### **Submission: SSD-14394209 New Bungendore High School**

As foreshadowed by our letter dated 12 July 2024, this letter constitutes Council's formal submission on the amended Bungendore High School proposal, as determined by Council at the ordinary meeting held 14 August 2024 (Resolution No 370/24).

## Attachment 1 - Comments on Amended SSDA Proposal – Bungendore High School – August 2024

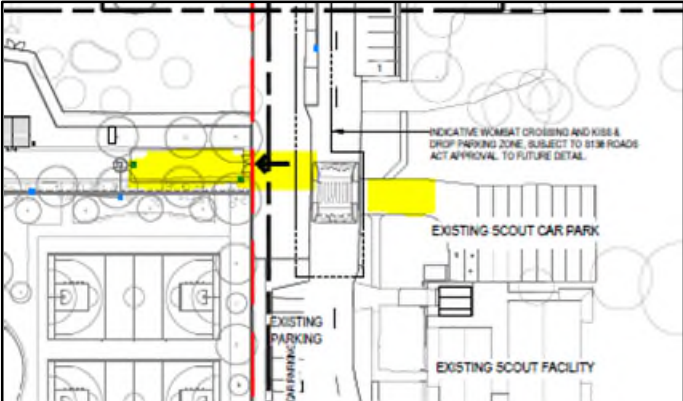
Matter Raised by Council on Original DA	Council Submission – 15 August 2021	Outcome
1. Permissibility	The amended application's removal of development from Bungendore park and Bungendore Common Crown land is noted but greater clarity is sought in relation to the proposed level of dependence the school will have on the Crown Land for a student hall and open space use and what mechanisms are proposed to formalise these arrangements.	<b>Objection</b> until suitable arrangements are agreed.

2. Crown Land Impacts	As above.	<b>Objection</b> until suitable arrangements are agreed.
3. Utilities	<p>Previous commentary stands and previous recommended conditions of consent remain relevant.</p> <p>The Infrastructure Management Plan Report does not consider impacts of stormwater volumes created by the school site and where this flow might go, or if the existing network is sufficient to accept it. An assessment is required for the stormwater demands/production from the site, what local stormwater network is present, what the impact is to the local stormwater network and adjacent public areas, noting localise flooding due to the additional flow from the school is not acceptable.</p> <p>The proposed landscaping plans do not show the easements which have previously been agreed with Schools Infrastructure for stormwater and water mains along Majara Street. Staff are therefore unable to determine where the proposed plantings/features are in relation to the easement/s. It is noted that the architectural drawings do show the easements, and indicate that many trees, seats and footpaths to be in those easements. Trees are unacceptable and Staff object to seating proposed in the easement/s. Accordingly, the development, including landscaping, must comply with Council's Development Adjacent to Water Sewer and Stormwater Mains Policy. Should seating or other landscaping elements be placed within easements in contravention of Council's aforementioned policy, Council will not be responsible for repairing or reinstating any landscaping features within the easement/s in the event that those features are affected by routine or emergency maintenance.</p> <p>Where does the overflow from the underground rainwater tank go when it has reached capacity?</p>	<b>Objection</b> until comments suitably addressed.

4. Erosion and Sediment Control	Previous commentary stands and previous recommended conditions of consent remain relevant.	As per previous commentary.
5. Traffic and Roads	<p><u>Traffic Generation</u></p> <p>Previous traffic generation calculation error has been corrected and addressed within the updated PDC Consultants Transport Assessment report dated 11 June 2024. The resulting trip generation is 225 trips in the AM and 193 trips in the PM and are an overall decrease than what was initially anticipated in previous assessments. Considering the number of students within the proposed school catchment, concern is raised over the validity of the presumed traffic generation as it fails to acknowledge the likely high growth demand this school may experience. Accordingly, staff consider</p>	<b>Objection</b> until comments suitably addressed.
